CONNECTICUT RIVER FLOOD CONTROL HARTFORD DIKE RIVERFRONT, MORGAN ST. TO STA. 96+73 TYPICAL CROSS SECTIONS NO. 4		
CONNECTICUT RIVER		CONNECTICUT
IN 135 SHEETS	SCALE: 1 IN. = 20 FT.	SHEET NO. 27

U. S. ENGINEER OFFICE, PROVIDENCE, R. I., MAY 1940		
SUBMITTED: <i>Robert B. Newlin</i>	APPROVAL RECOMMENDED: <i>W. B. Burns</i>	APPROVED: <i>W. B. Burns</i>
SENIOR ENGINEER HEAD, DESIGN SECTION	PRINCIPAL ENGINEER CHIEF, F.C. ENGINEERING DIV.	LT. COL. CORPS OF ENGINEERS DISTRICT ENGINEER
DESIGNED: <i>W. B. Burns</i>	DRAWN: D. L. B. & A. K. TRACED: J. E. D. CHECKED: <i>W. B. Burns</i>	FISCAL YEAR 1940 FILE NO. CT-4-2487

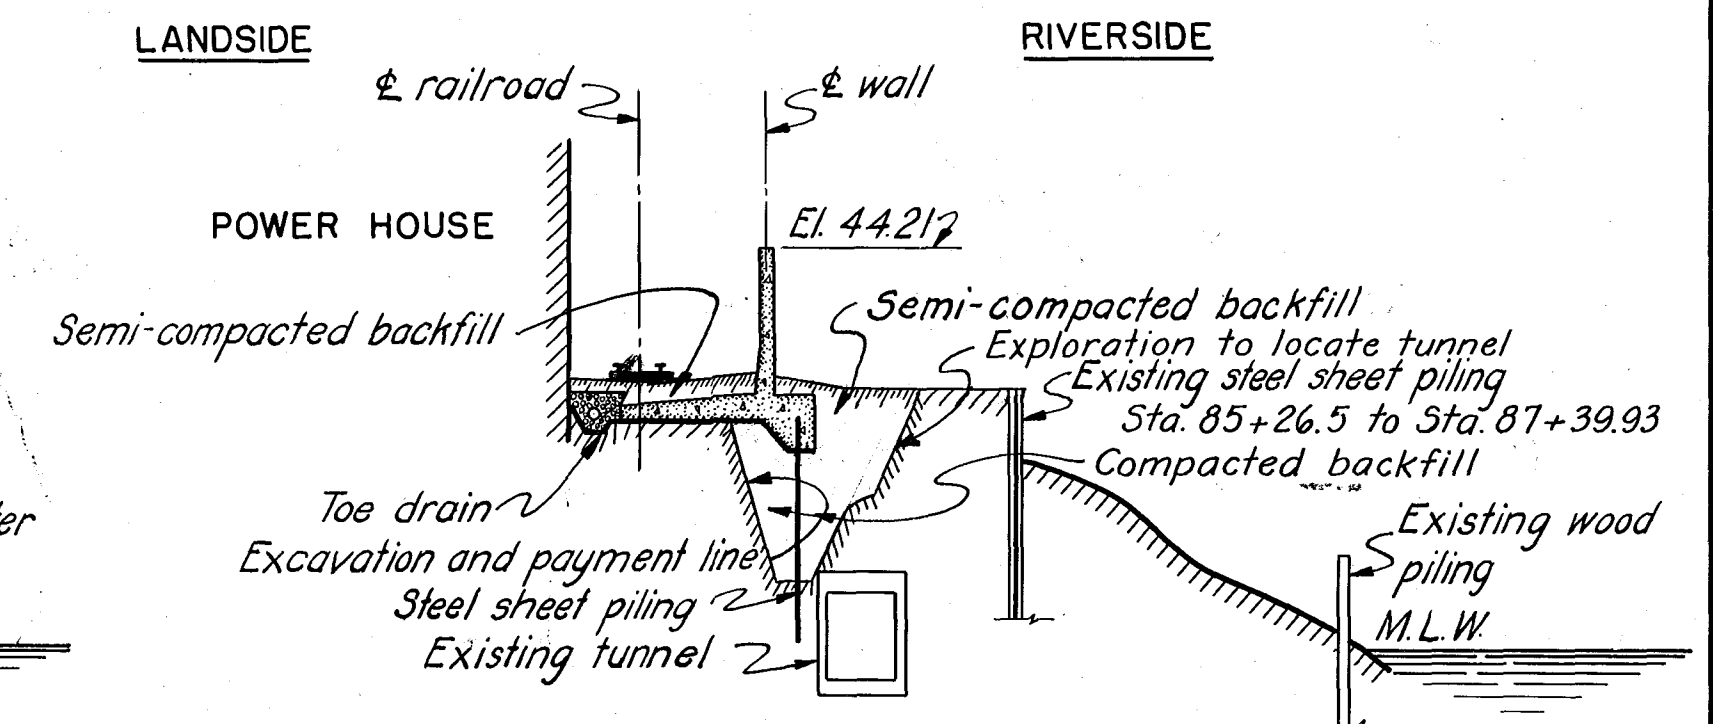
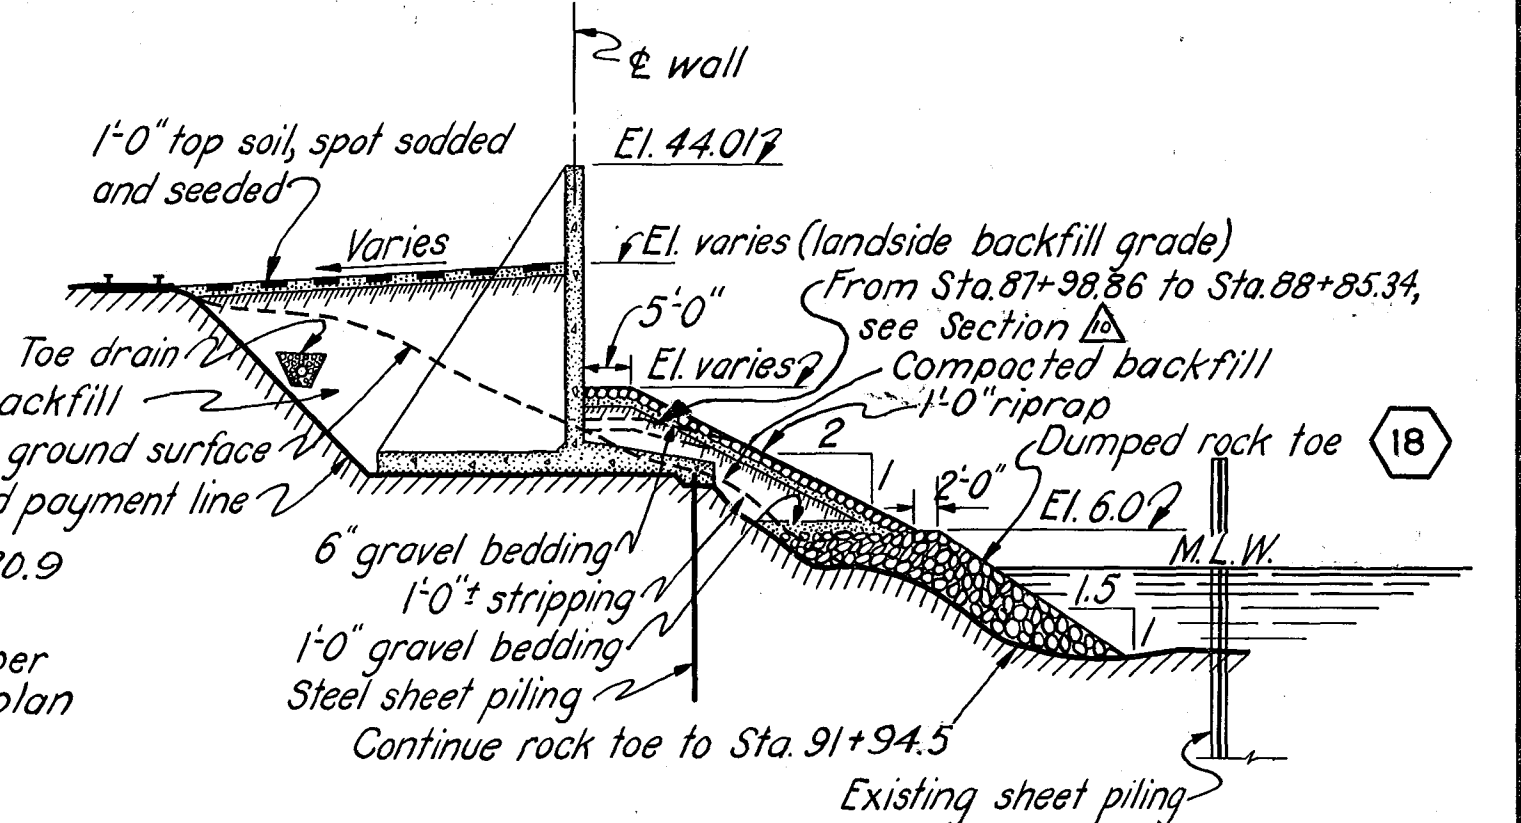
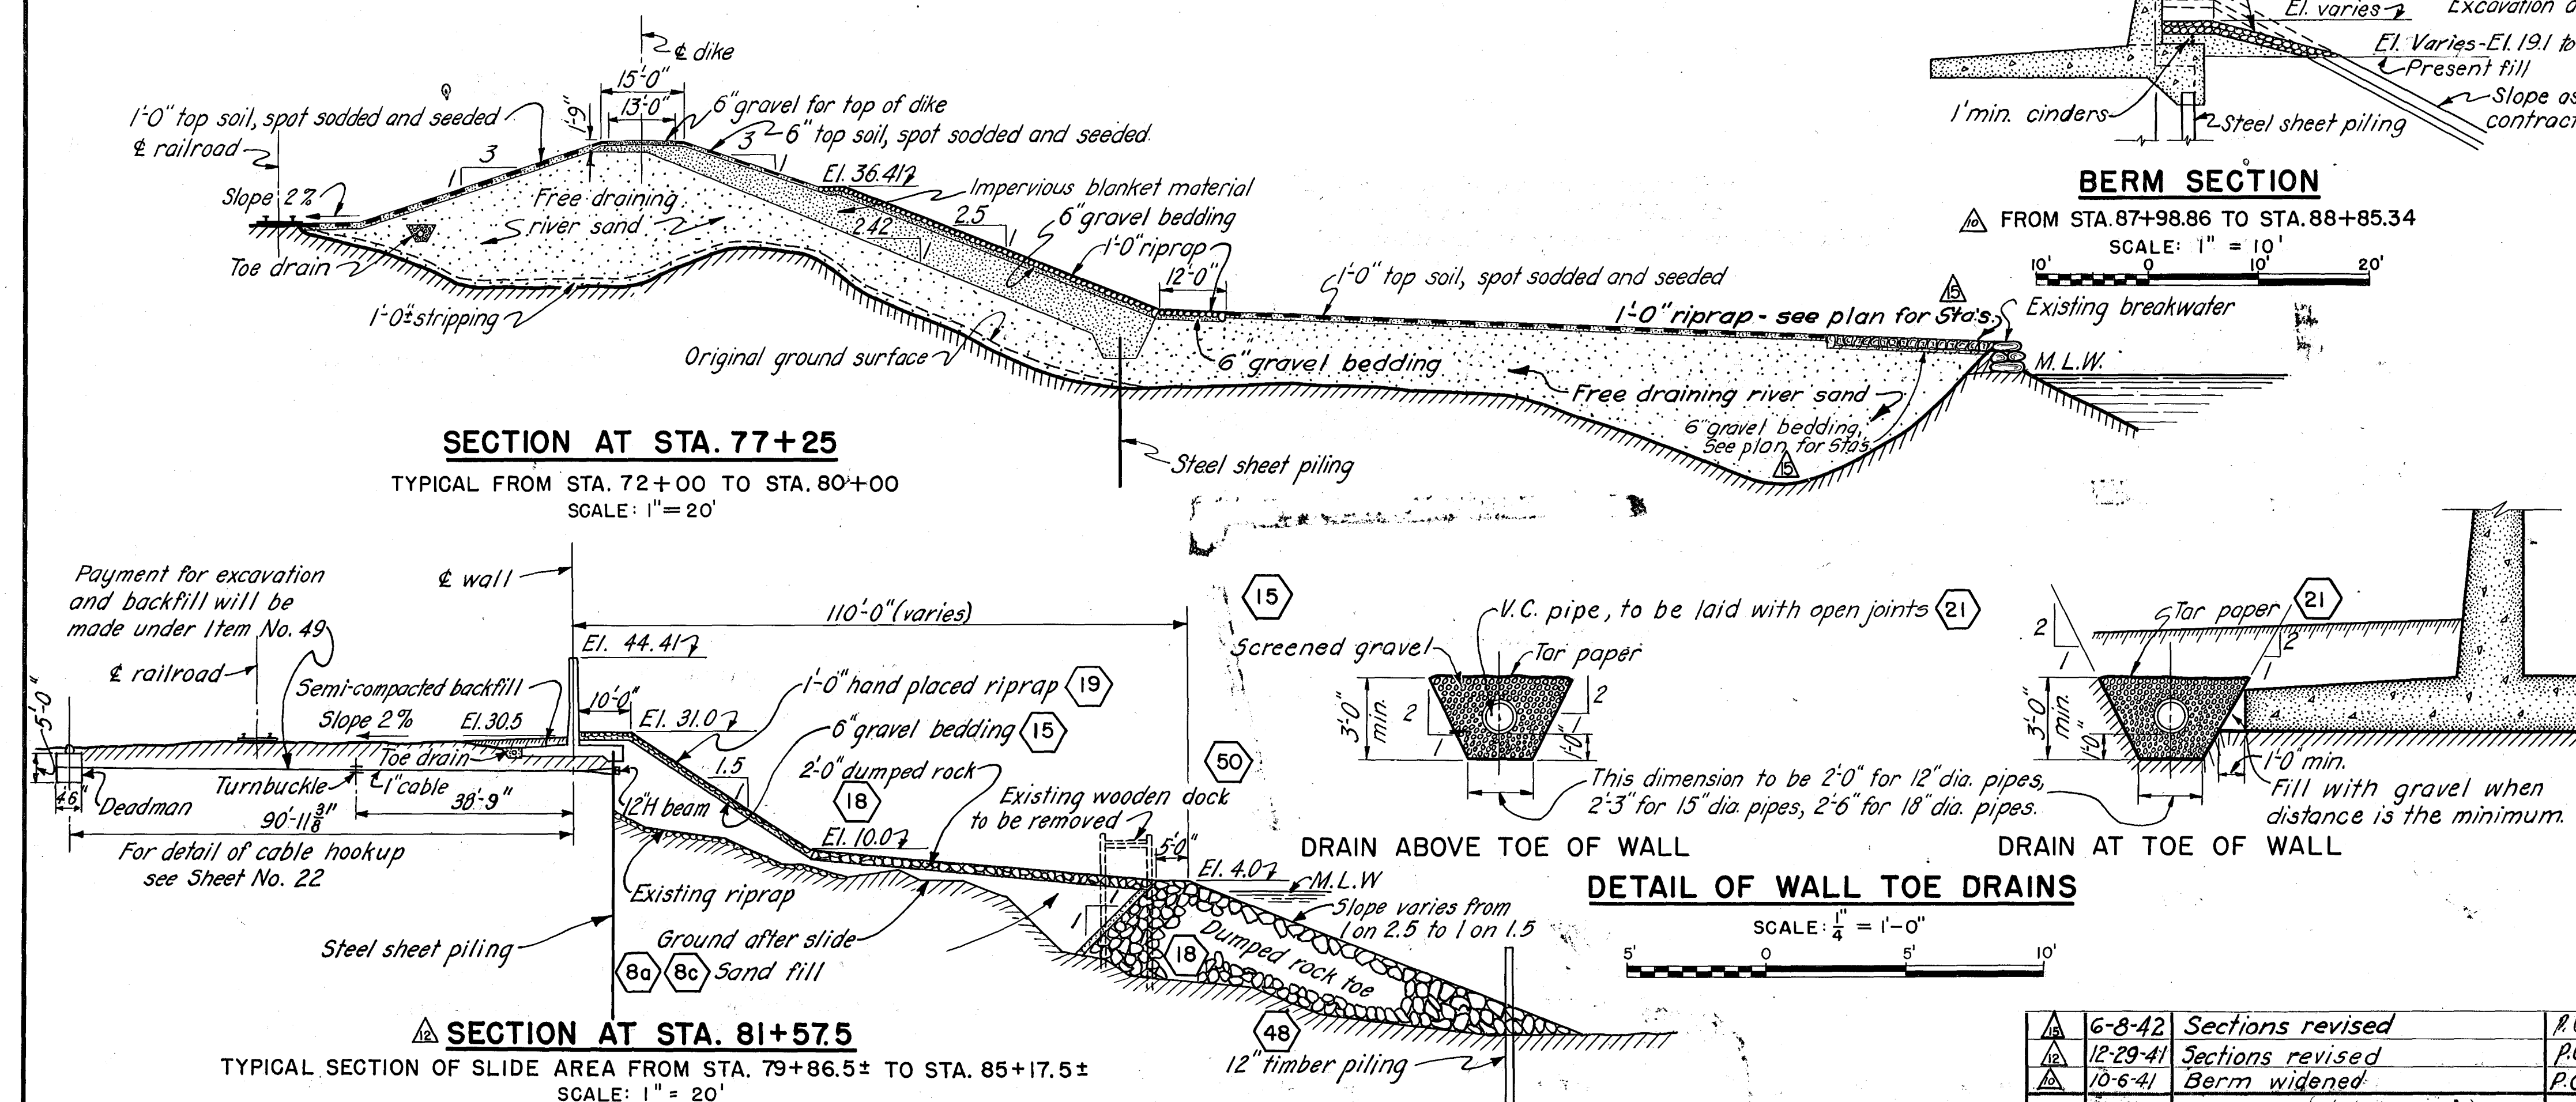
Due to slide on 24 July 1941 information shown on this sheet is not applicable.

For "As-built" information in this area see Sheets No. 1 thru 7 incl.; Reconstruction at slide Sta. 44+45.68 to Sta. 65+00 Item Ht 547bR; also see Sheet No. 26A, File No. Ct-4-3912.
